Accessibility Design Review Report

Forestway Shopping Centre
Redevelopment,
Warringah Road & Forest Way,
Frenchs Forest, NSW

Prepared by:	Angela Chambers
Prepared for:	Point Polaris
Job No:	75741
Date:	24 September 2018
Revision:	01
Phased:	DA

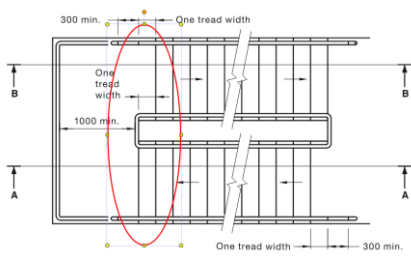
All public circulations stairs and ramps (excluding fire-isolated stairs/ramps) must be provided with handrails/kerb rails to both sides, handrail extensions & turndowns, nosing strips (Stairs) and Tactile Ground Surface Indicators (TGSIs).

Circulation stairs and ramps will be required to be set-back from transverse paths of travel so that handrail extensions do not protrude into corridor paths of travel.

Offsetting the stair at the mid landing will allow a continuous single handrail which will not require vertical sections.

Offsetting the stair at the mid landing will allow a continuous single handrail which will not require vertical sections.
